## Site Inspection Report

PROJECT REF: <b>WWW</b>				DATE: Monday, July 28, 2014		
DESCRIPTION OF WORK: Alterations						
ADDRESS: 39 The Old Common, Chalford, Stroud, Gloucestershire, GL6 8HH,						
SITE CONTACT: Mrs Williams Tel:				WEATHER/TEMP: Mild		
PRESTART	FOUNDATIONS	DPC/OVERSITE	DRAINS	SUPERSTRUCTURE	FIRST FIX/INSULATION	
<input type="checkbox"/>	<input type="checkbox"/>	<input type="checkbox"/>	<input type="checkbox"/>	<input type="checkbox"/>	<input type="checkbox"/>	
LIFE SAFETY INSTALLATIONS		COMMISSIONING	COMPLETION	OCCUPATION	OTHER	PLEASE TICK BOX
<input type="checkbox"/>		<input type="checkbox"/>	<input type="checkbox"/>	<input type="checkbox"/>	<input checked="" type="checkbox"/>	(right click, properties and select checked)
<b>COMMENTS</b>						
COMMENTS Progress inspection undertaken, following noted.

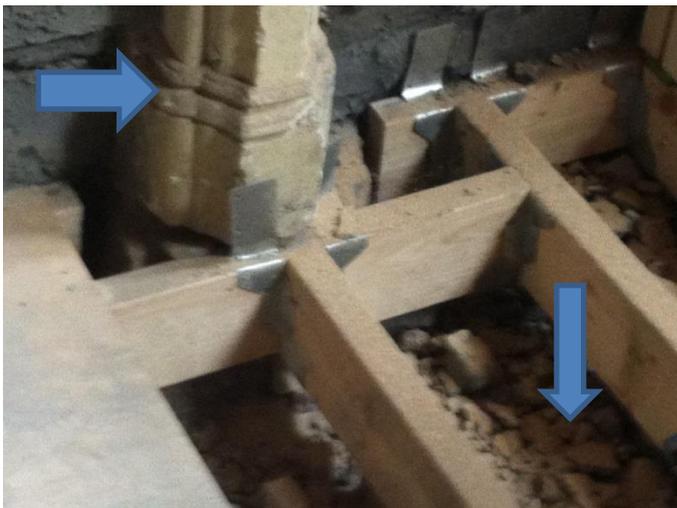
1. Any rubble which has been back filled under the suspended timber floors in both buildings is to be removed and a polythene dam is to be laid on the existing ground covering (soil) and lap with the dpc under the dwarf support walls to the suspended timber floors.
2. In the school building the suspended timber floor joists are to be cut back 50mm from the face of the existing walls and strip of dpc placed between the joists and the wall.
3. A guarantee has not been requested for the existing timbers being reused although all are going to be treated.

Engineered floor joists adjacent to party wall

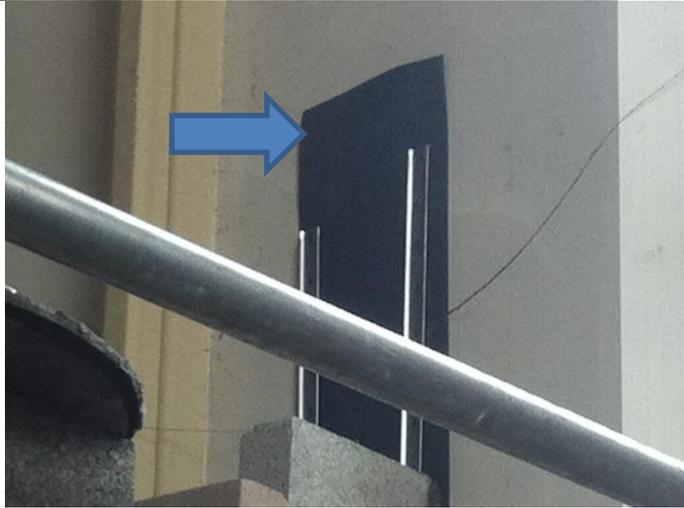
1. There is an existing slate dpc to both buildings. An injected dpc is therefore not proposed.
2. In the school building some of the new floor joists can be seen and centres are 600mm. Contractor said that engineer specified 50 x 150mm joists but 200mm have been used. Generally look to be ok especially as they are all being supported off dwarf walls which will reduce the spans. Has a floor joist layout plan for the suspended timber floors been approved?
3. In both buildings work has commenced on the party walls, in the main building they are generally around first floor height. Noted as dense concrete blocks with fibreglass insulation. Contractor confirmed that sound testing is proposed to all units.
4. In the main building the unit nearest the entrance has engineered floor joists in place for the first floor. **Have details been requested?**
